901 NORTH CAPITOL STREET NE ZONING COMMISSION SUBMISSION

PREVIOUSLY APPROVED - ZC CASE NO. 21-09

901 NORTH CAPITOL STREET NE ZONING COMMISSION SUBMISSION : JUNE 16, 2023

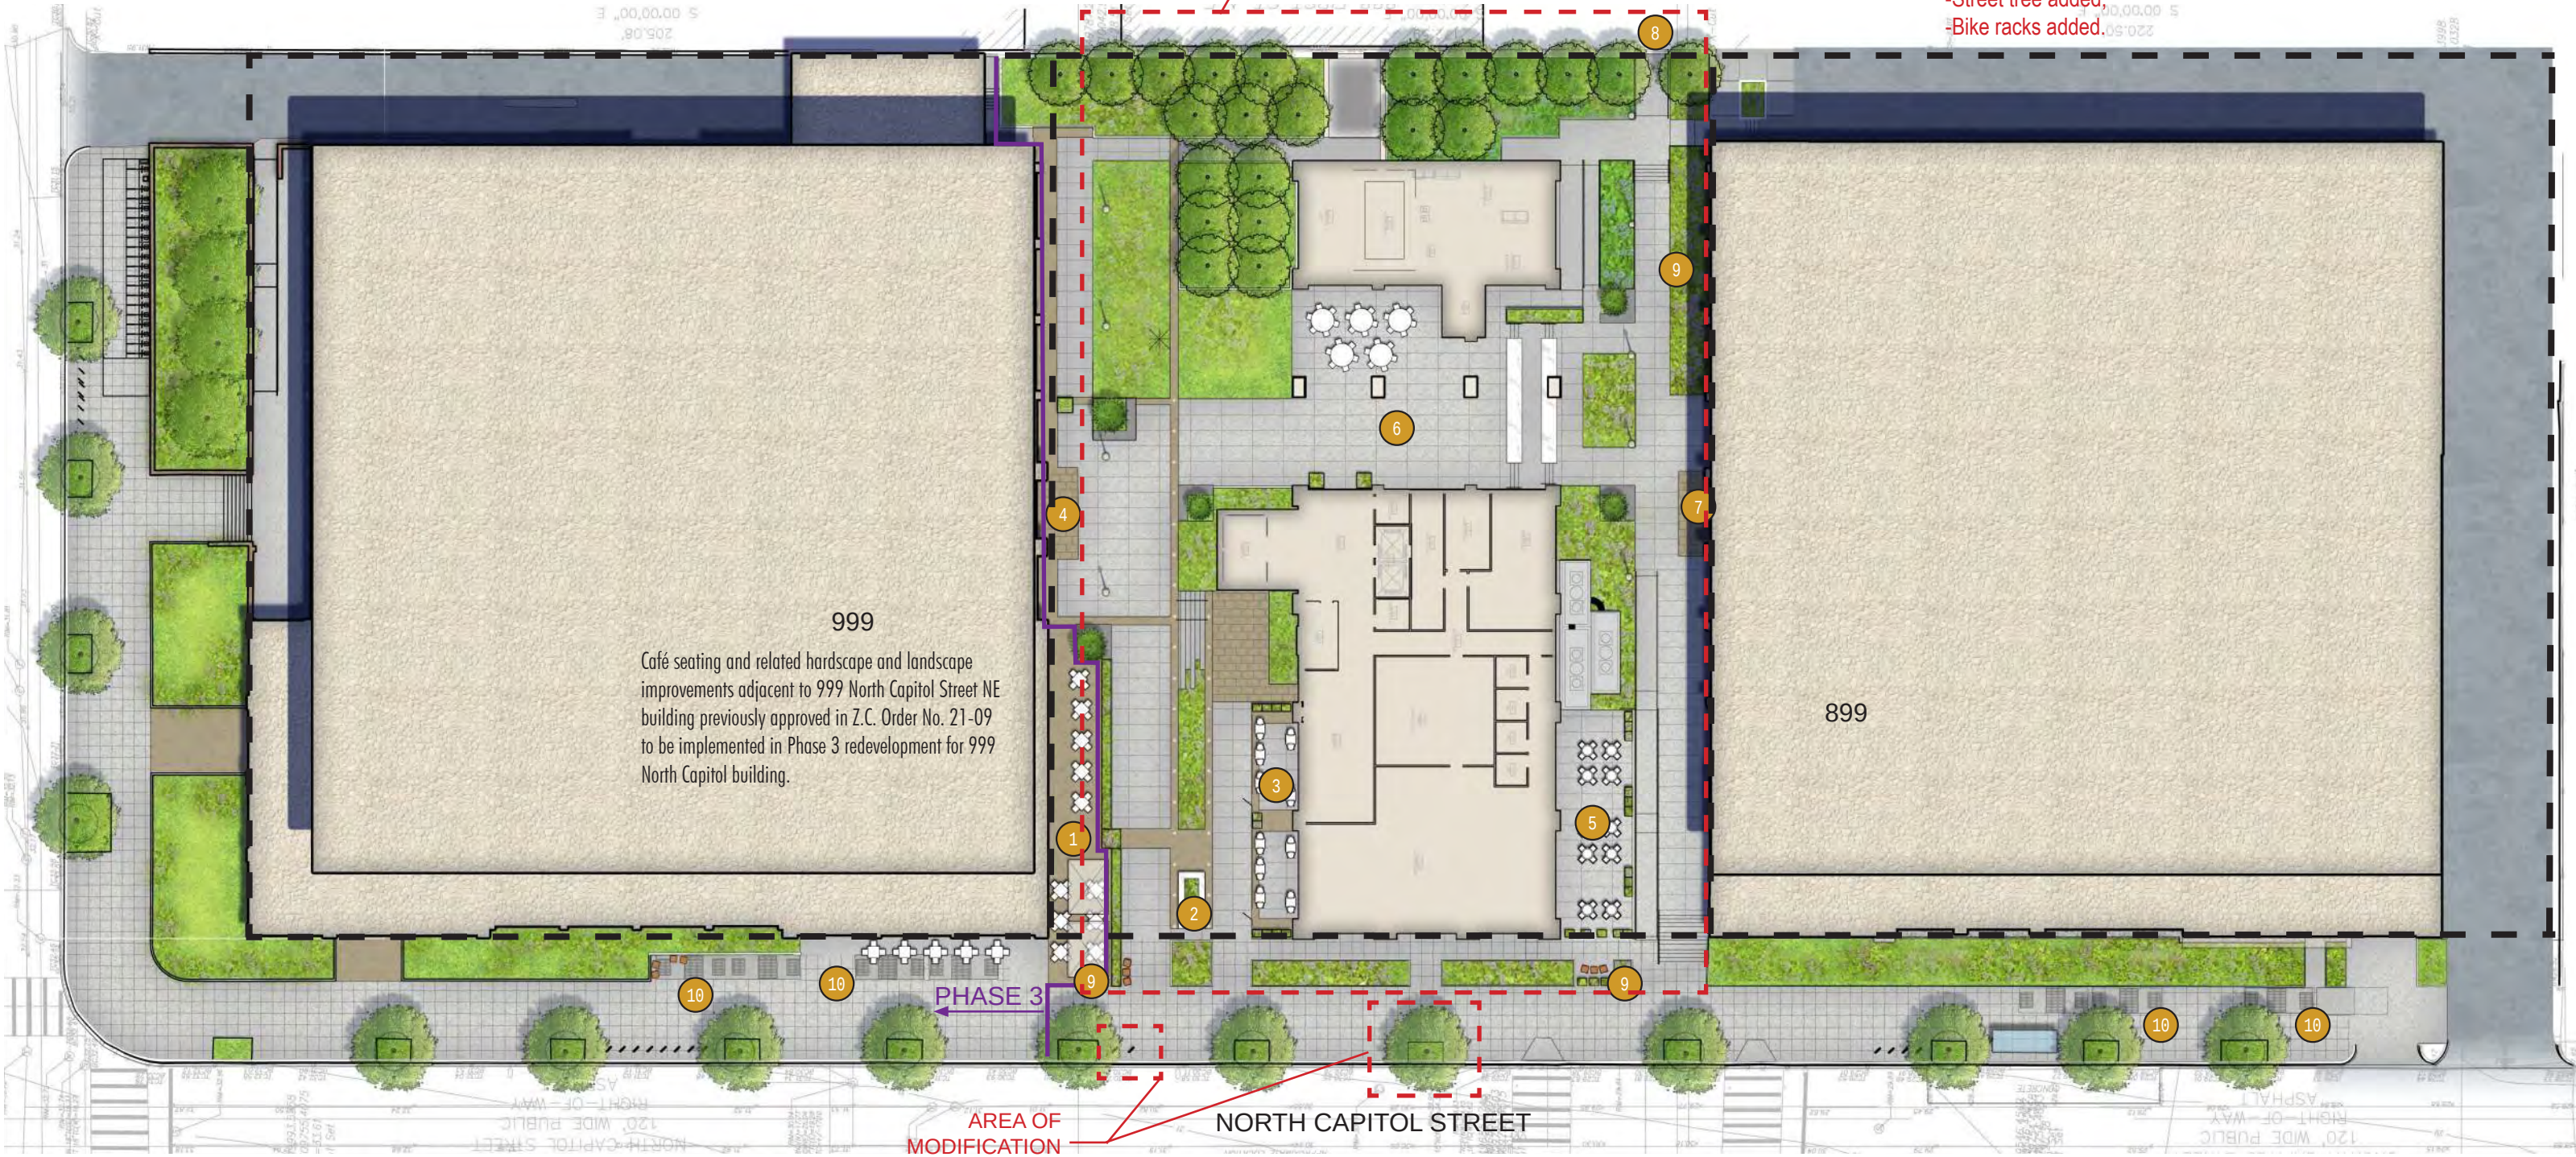
Modifications:

- Trees, planting and green roof area added in plaza;
- Unit pavers updated to smaller areas of concrete paving;
- Transformer area updated;
- Furniture in covered passageway revised;
- Decorative pots and planters revised in quantity and size;
- Public seatings relocated;
- Street tree added;
- Bike racks added.

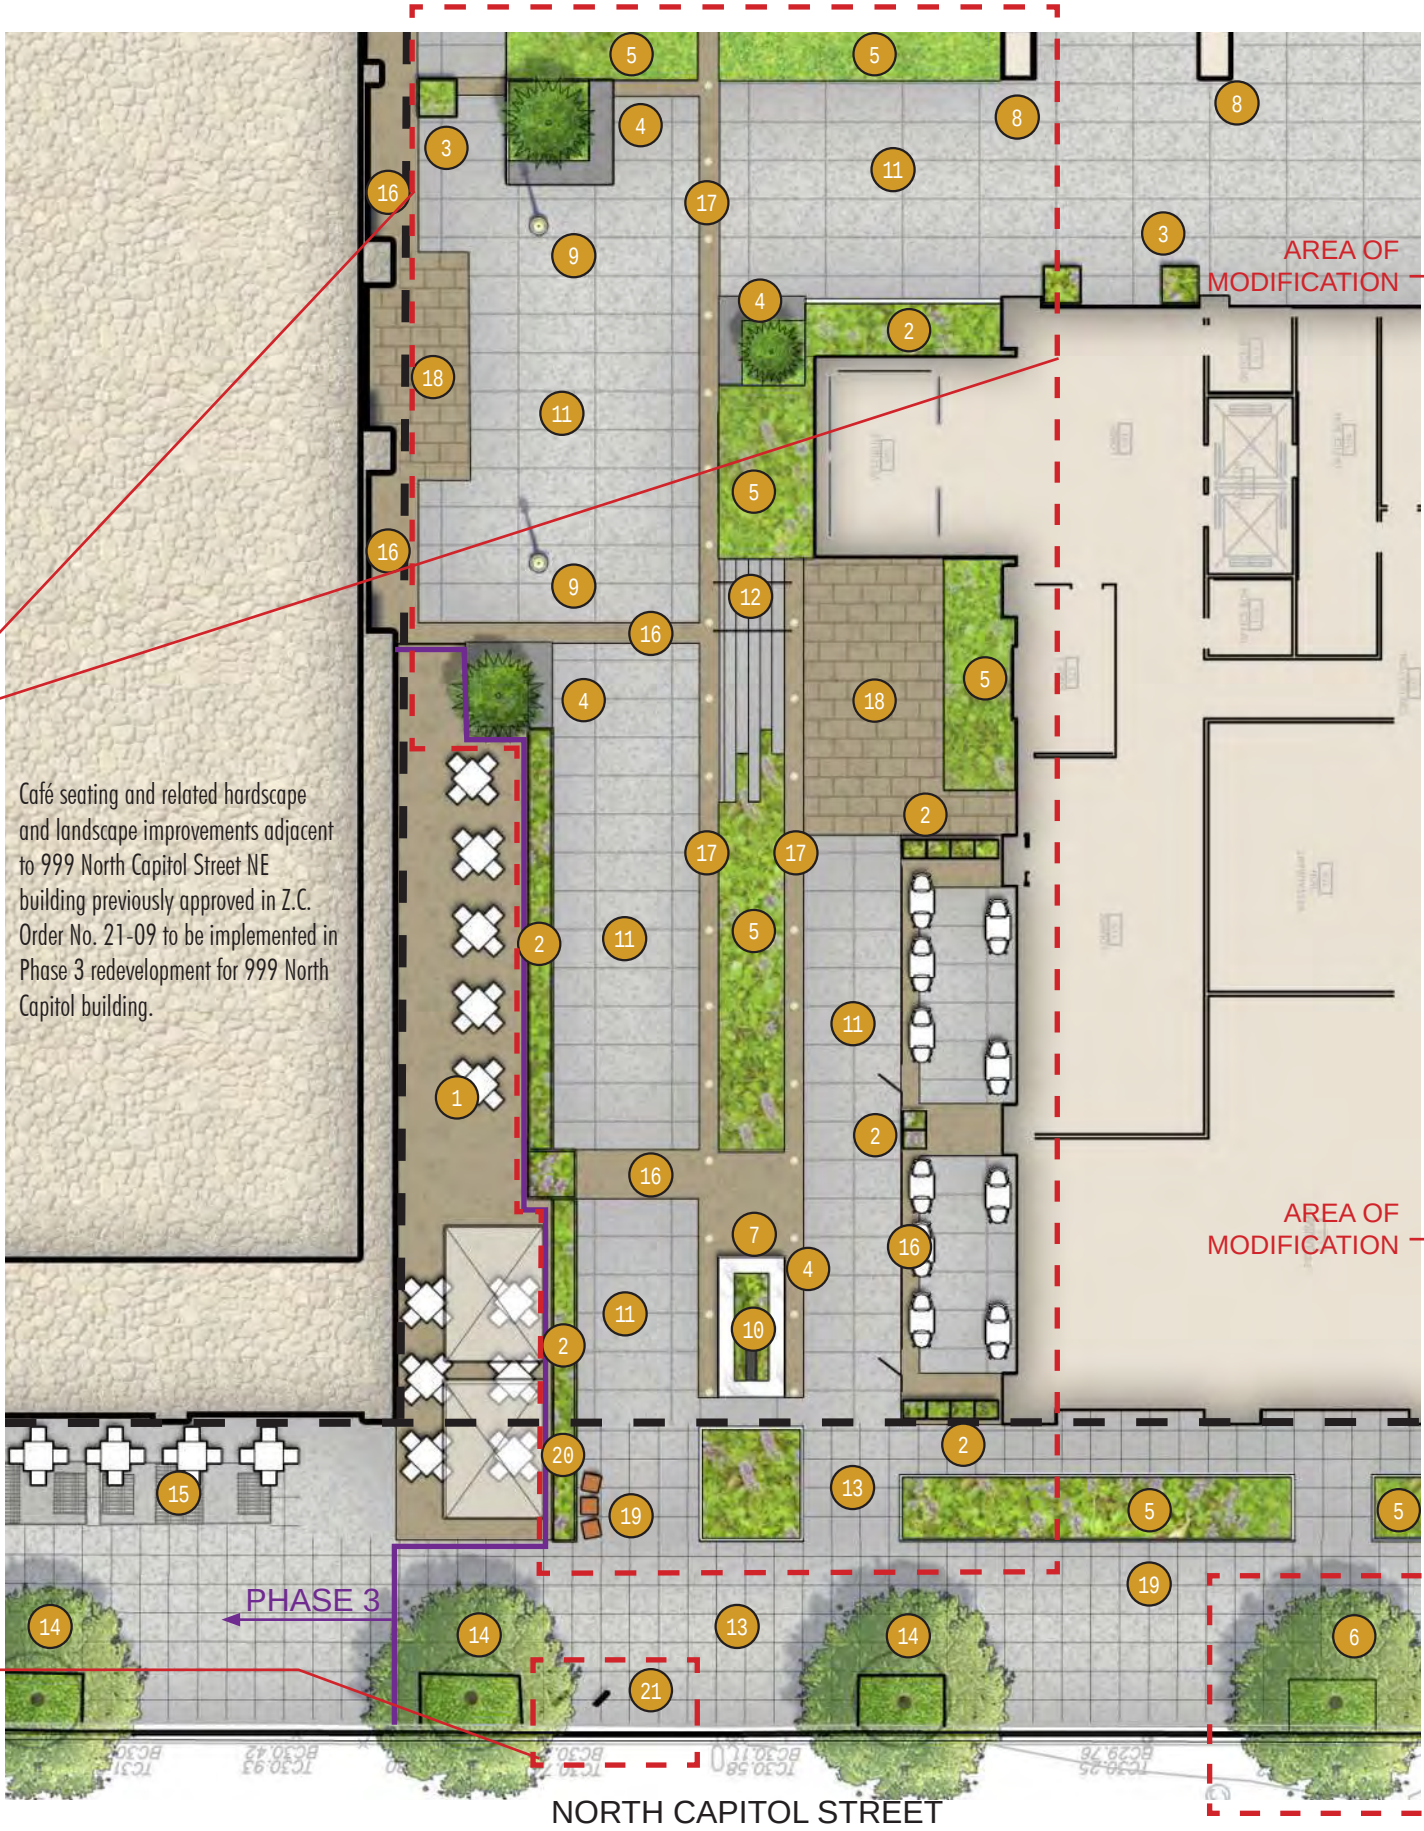
- Modifications:
- Trees, planting and green roof area added in plaza;
 - Unit pavers updated to smaller areas of concrete paving;
 - Furniture in covered passageway revised;
 - Decorative pots and planters revised in quantity and size;
 - Public seatings relocated;
 - Street tree added;
 - Bike racks added.

Café seating and related hardscape and landscape improvements adjacent to 999 North Capitol Street NE building previously approved in Z.C. Order No. 21-09 to be implemented in Phase 3 redevelopment for 999 North Capitol building.

SOUTHWEST BUILDING RENDERING : A07 - REV

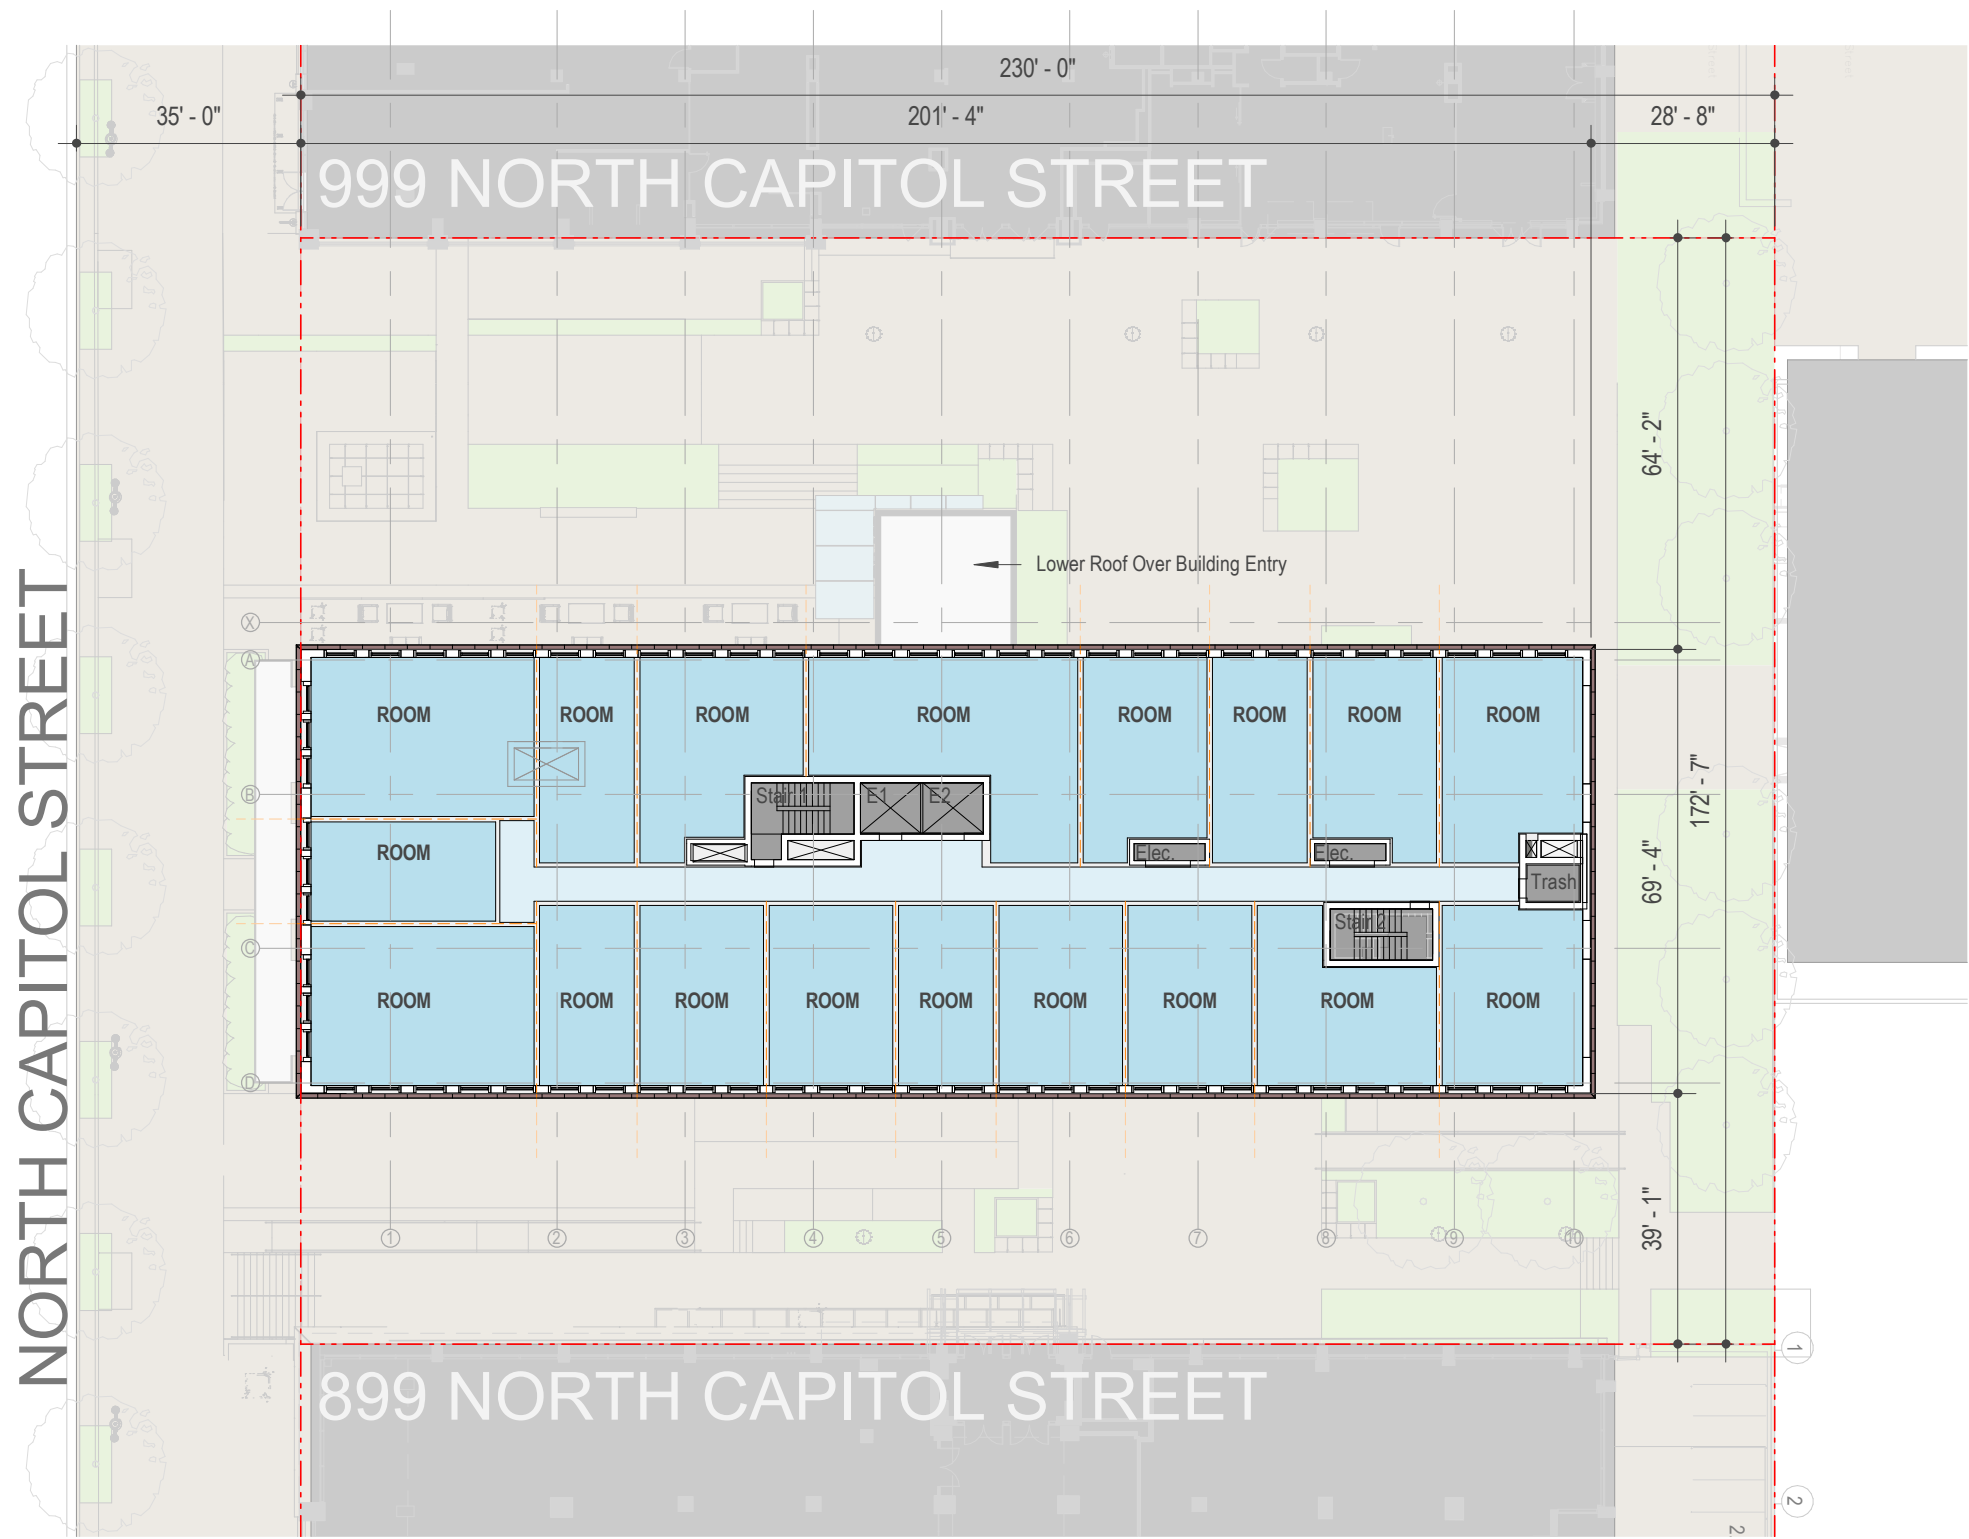
AREA OF MODIFICATION:
WINDOWS UPDATED TO TWO SIDE
BY SIDE SINGLE HUNG WINDOWS

AREA OF MODIFICATION:
STOREFRONT UPDATED: FIXED
WITH LOWER OPERABLE WINDOWS
